7.0 Instrumentation and Control Systems

7.1 Introduction

The information in this section of the reference ABWR DCD, including all subsections and tables, and figures, is incorporated by reference with the following departures and supplements.

Figure 7.1-1 ~~SSLC Self-Test System~~ Diagnosis

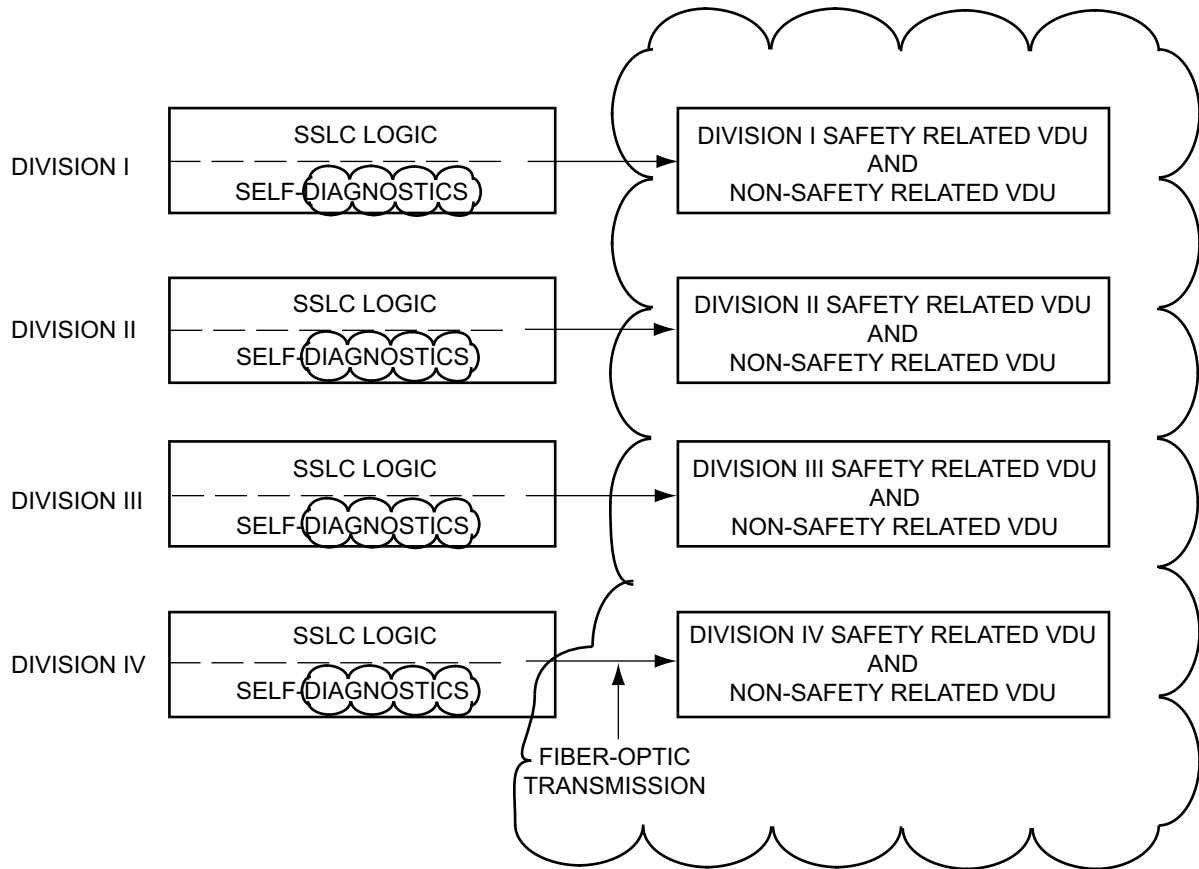
STD DEP T1 3.4-1 (Figure 7.1-1, 7.1-2)

STD DEP T1 3.4-1

Each individual safety-related system utilizes redundant channels of safety-related instruments for initiating safety action. The automatic decision making and trip logic functions associated with the safety action of several safety-related nuclear steam supply systems (NSSS) are accomplished by ~~a four division correlated and separated protection logic complex called the~~ safety system logic and control (SSLC). The SSLC includes multiple redundant divisions, which are separated from each other. The SSLC has four redundant divisions of sensors. Each division of sensors has a corresponding division that determines the trip status of the safety functions relative to the safety function setpoint. The SSLC has four redundant divisions for all actuation functions except for the engineered safety features. The engineered safety features have three divisions, corresponding to the maximum redundancy of the engineered safety features actuated components. Some engineered safety features functions are less than three-fold redundant and are assigned to the appropriate set of redundant divisions. The SSLC multi-divisional complex includes divisionally separate control room and other panels which house the SSLC equipment for controlling the various safety function actuation devices. The SSLC receives input signals from the redundant

Figure 7.1-2 Assignment of Interfacing Safety System Logic to SSLC Controllers

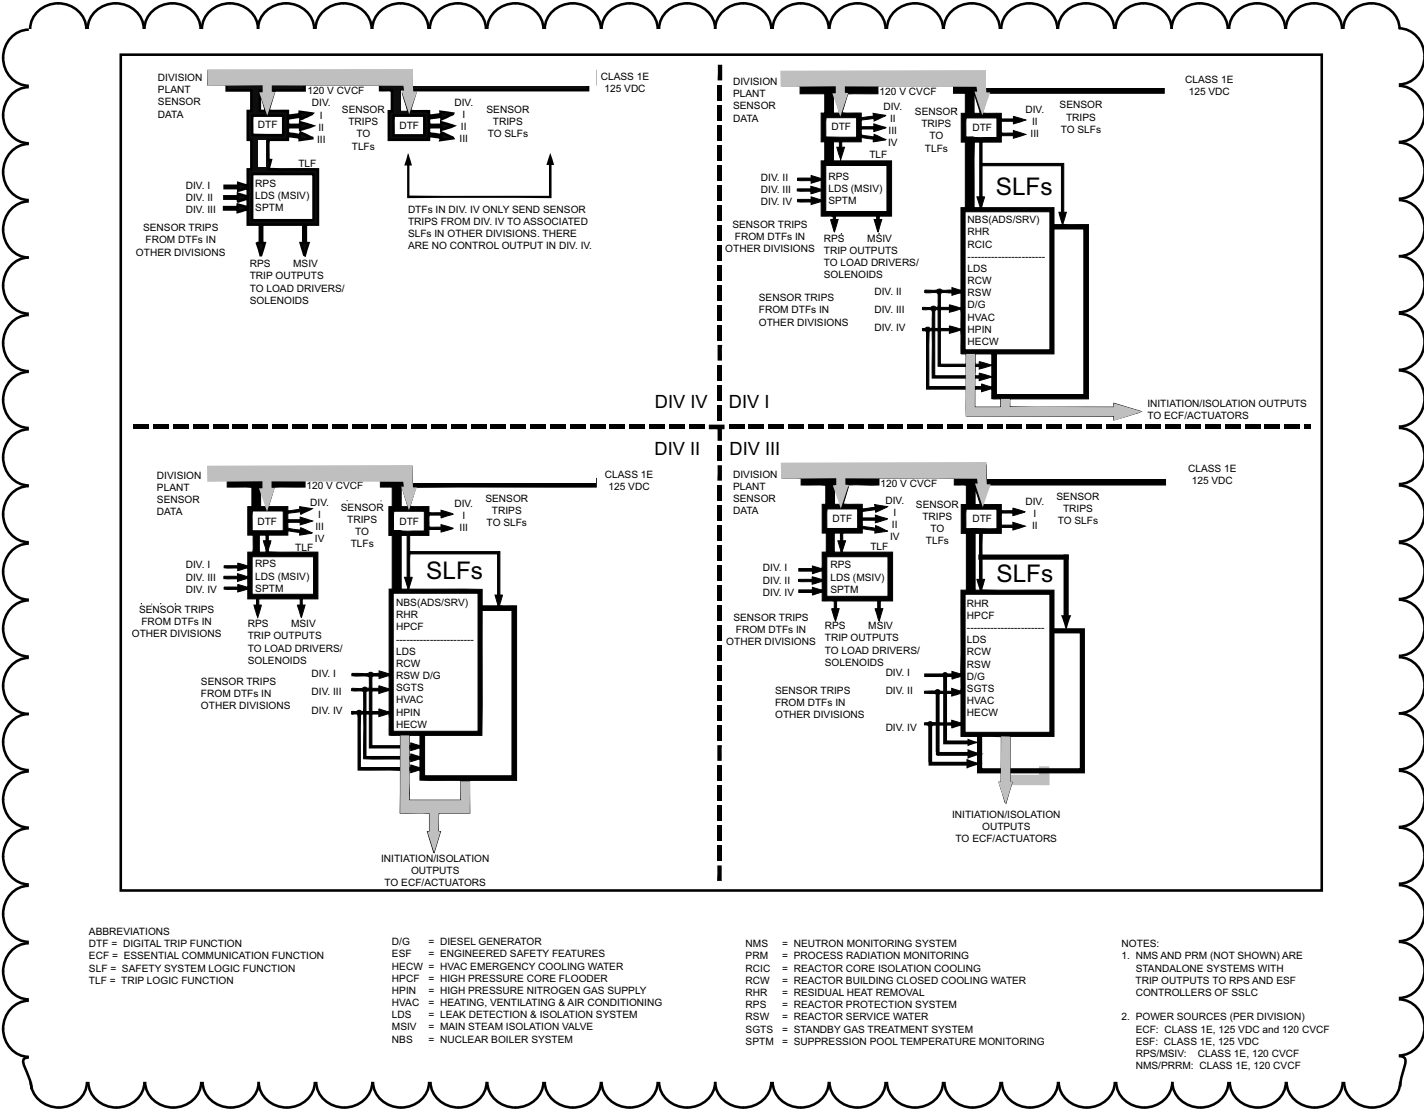
~~Divisional separation is also applied to the essential multiplexing system (EMS), which provides data highways for the sensor input to the logic units and for the logic output to the system actuators (actuated devices such as pump motors and motor-operated valves).~~ Systems which utilize the SSLC are include: (1) Reactor Protection (trip) System; (2) High Pressure Core Flooder System; (3) Residual Heat Removal System; (4) Automatic Depressurization System; (5) Leak Detection and Isolation System; (6) Suppression Pool Temperature Monitoring System; and (7) Reactor Core Isolation Cooling System. The equipment arrangement for these systems and other supporting systems is shown in Figure 7.1-2.
